This Service Information bulletin supersedes SI M17 06 12 dated **October 2012**.

Service Action: Retrofit of the Engine Coolant Temperature Sensor

R55

All with manual transmission and either the N14, N16 or N18 engine

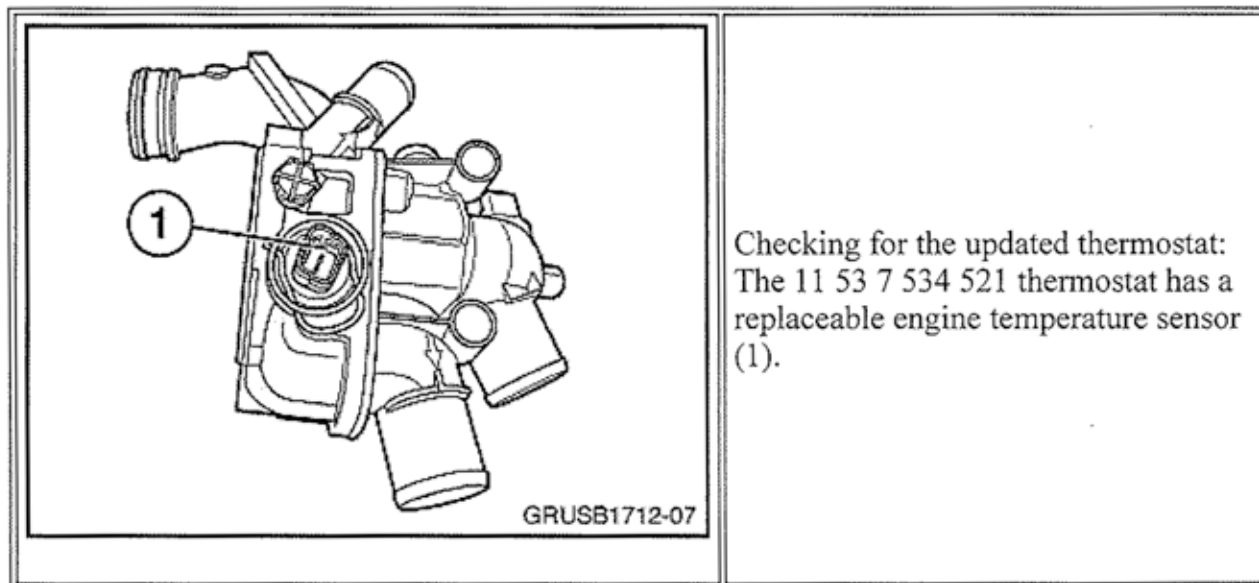
NEW There are two approved repair procedures, depending on parts availability. Both procedures involve installing an engine temperature sensor remotely and wiring this new sensor into the vehicle's engine harness. Only perform one of these recommended procedures when completing this Service Action.

NEW Procedure One requires the replacement of the upper coolant hose with a modified hose that

houses a new engine temperature sensor. An adapter harness needs to be fitted to the car to utilize this new sensor.

NEW Procedure Two requires the installation of a new engine temperature sensor, with integrated wire harness, installed in place of the thermostat bleeder screw.
